NOTICE OF DECISION

**CLASS 3 DESIGN REVIEW / CLASS 3 SITE PLAN REVIEW / DRIVEWAY
APPROACH PERMIT CASE NO.: DR-SPR-DAP19-12**

SUMMARY: Proposed development of a new 324 dwelling unit multi-family apartment complex with associated parking, play and recreation areas, landscaping, and common building.

FLOOR PLAN
GARAGE 2 (15 GARAGES)

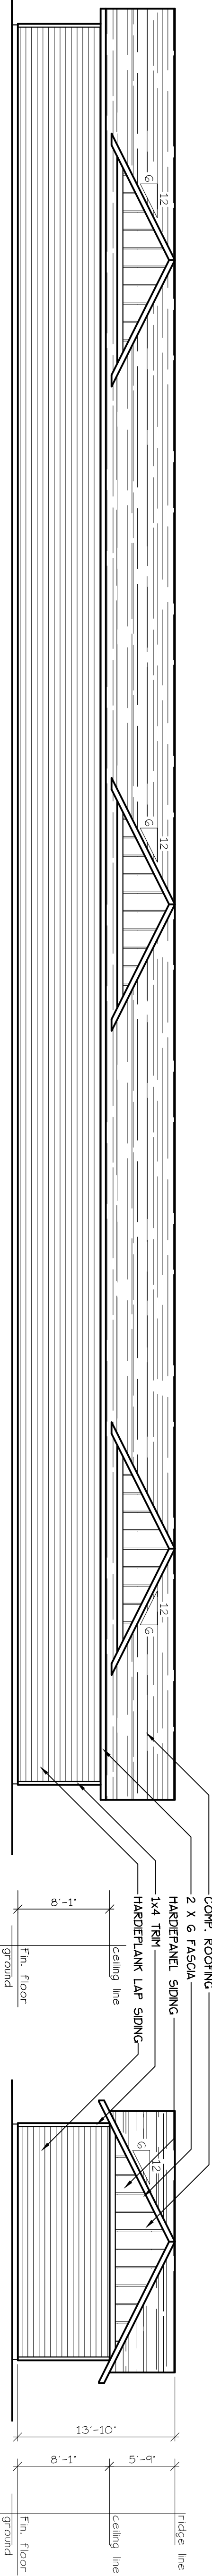
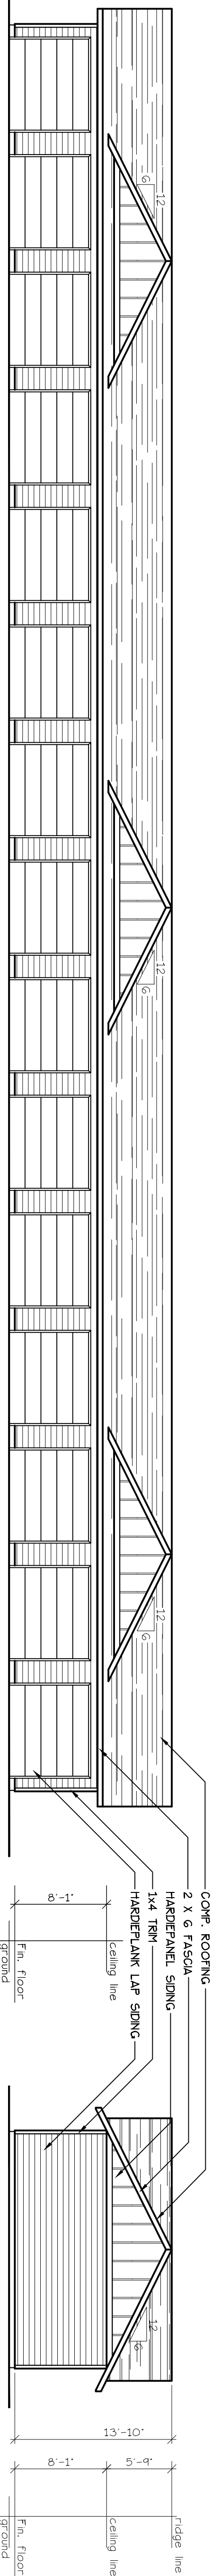
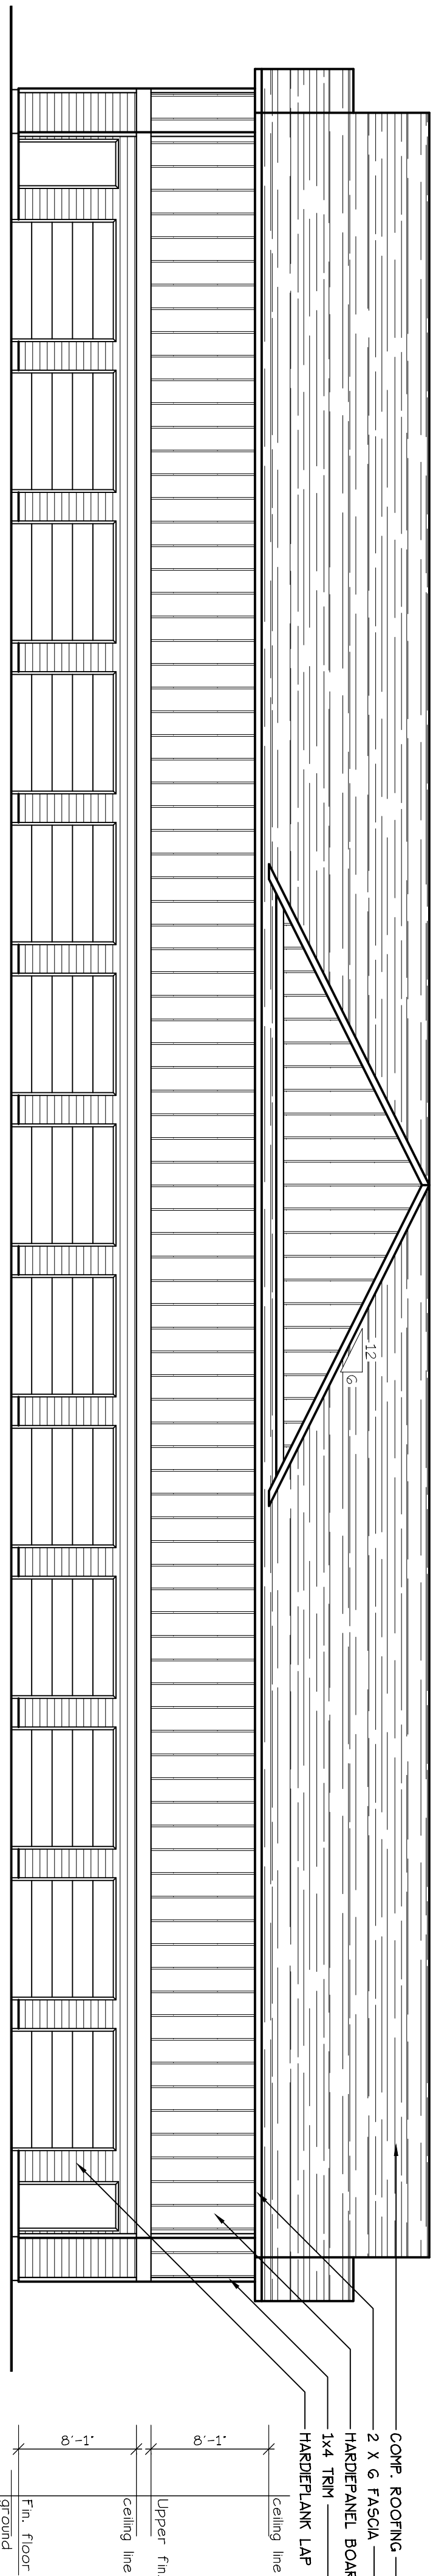
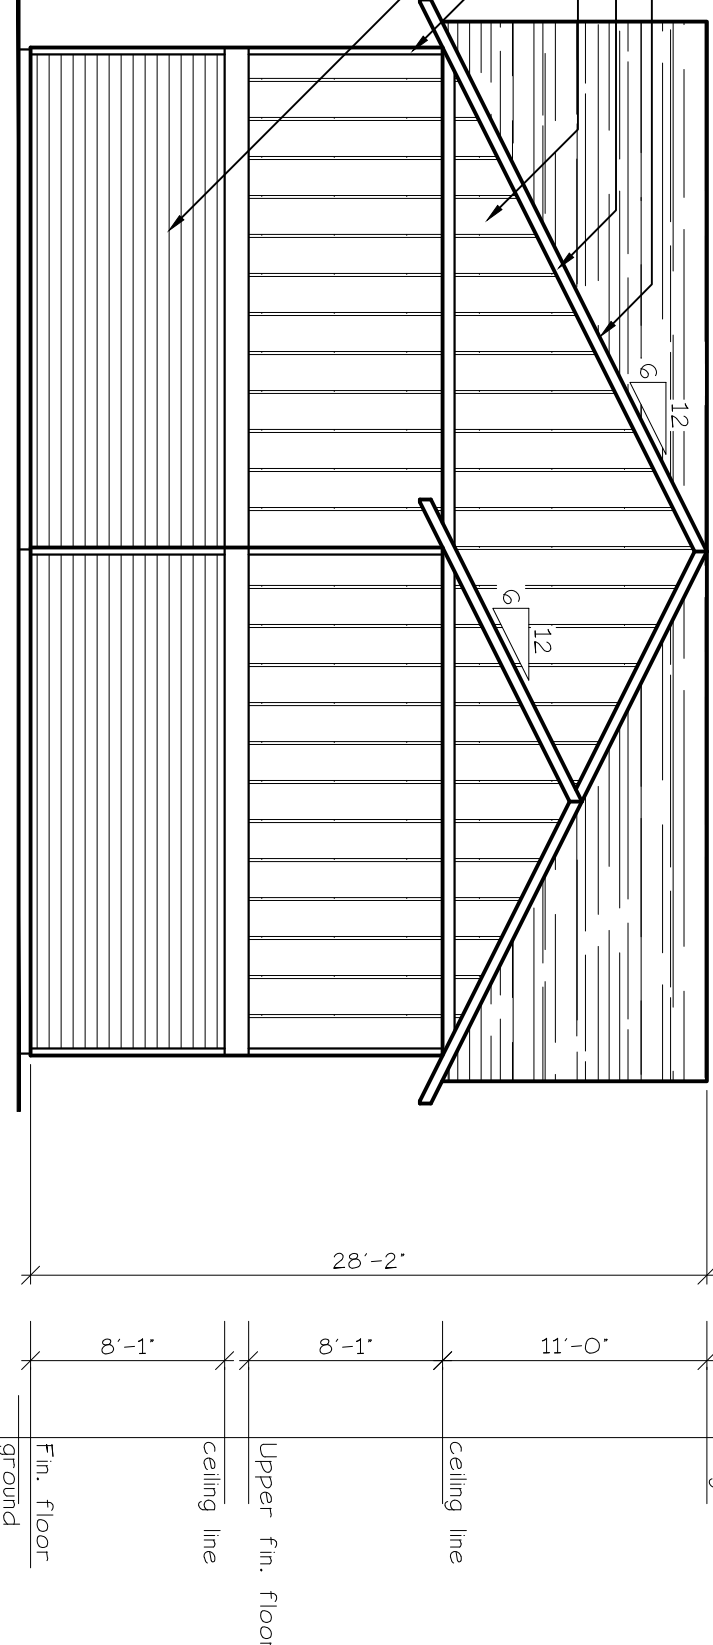
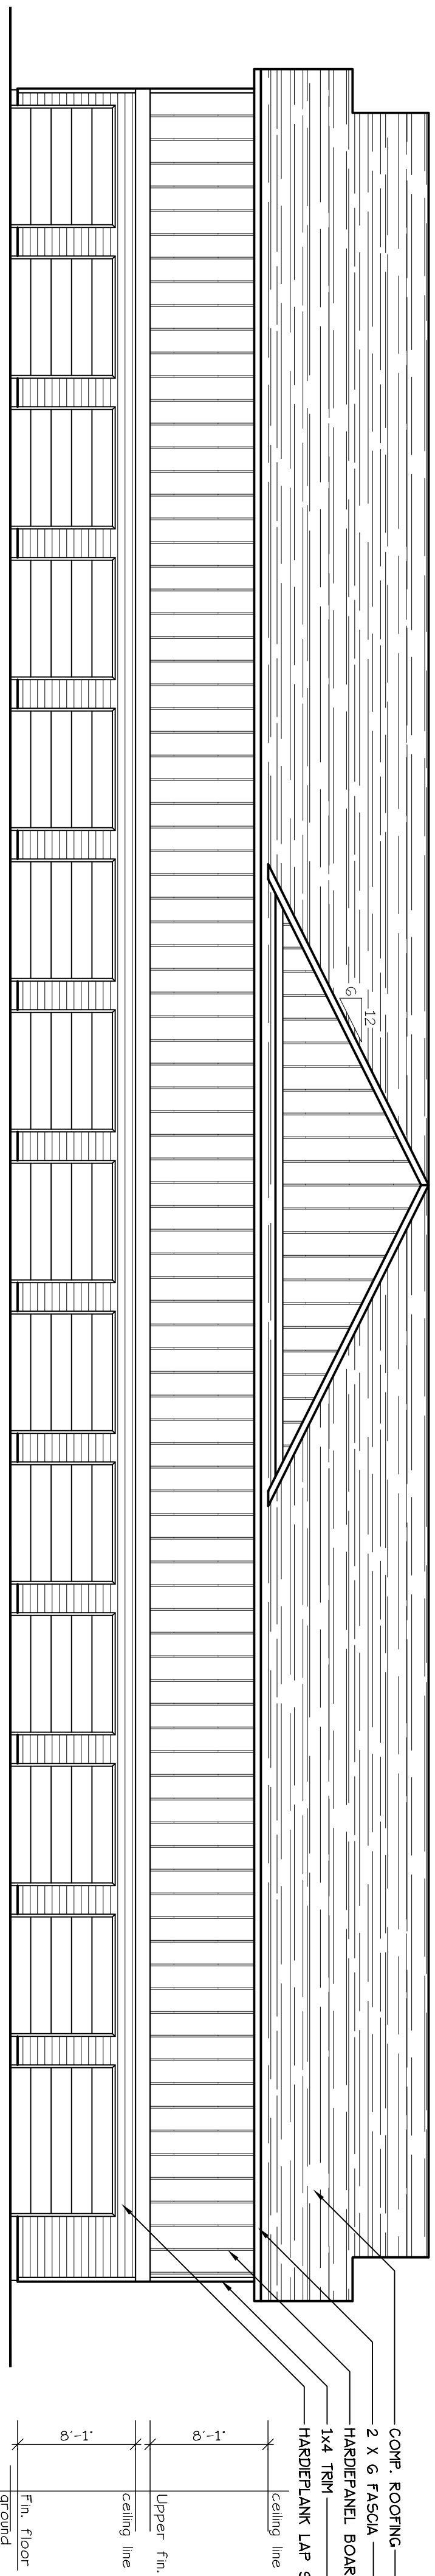
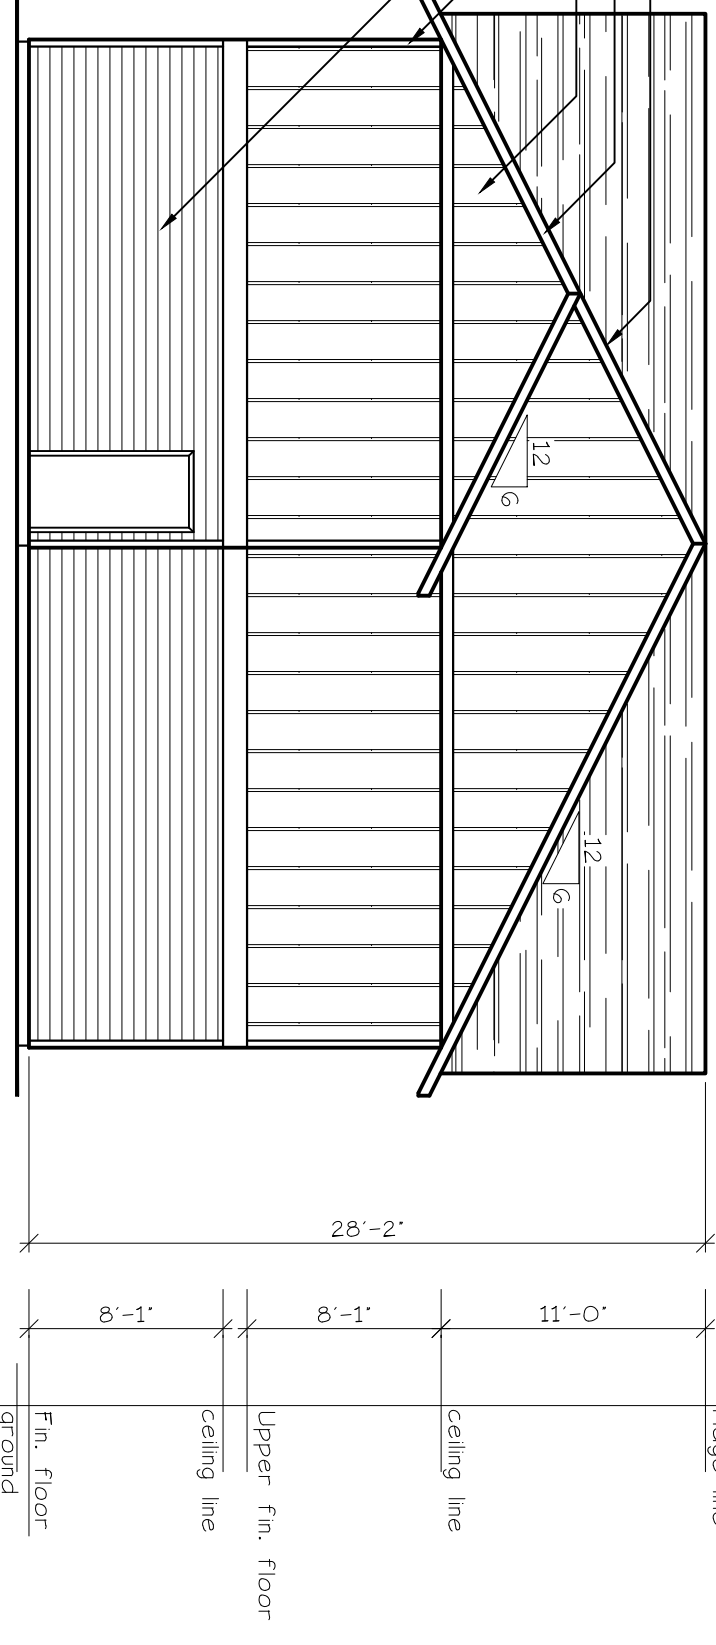
exterior wall. Three building exceeds the 150 feet in length standard. The proposed recreation building has articulation along the floor plan which breaks up the exterior walls meeting the guideline. The proposed Garage 2 and 3 exceed 150-feet in length and do not provide any articulation along the walls. The walls of the garages are long and monotonous, therefore to meet the guideline without altering the floor plan the following condition is recommended:

- Condition 4:** Garage 2 and 3 shall provide contrast and distinction by incorporating one or more of the following on at least 75 feet of the buildings:
- a) Vertically oriented lap siding, or horizontally oriented lap siding that is wider than that provided on the upper floor facades or is painted a different color than the upper floor facades; or
 - b) A siding material different from that used in the other portions of the building facades.
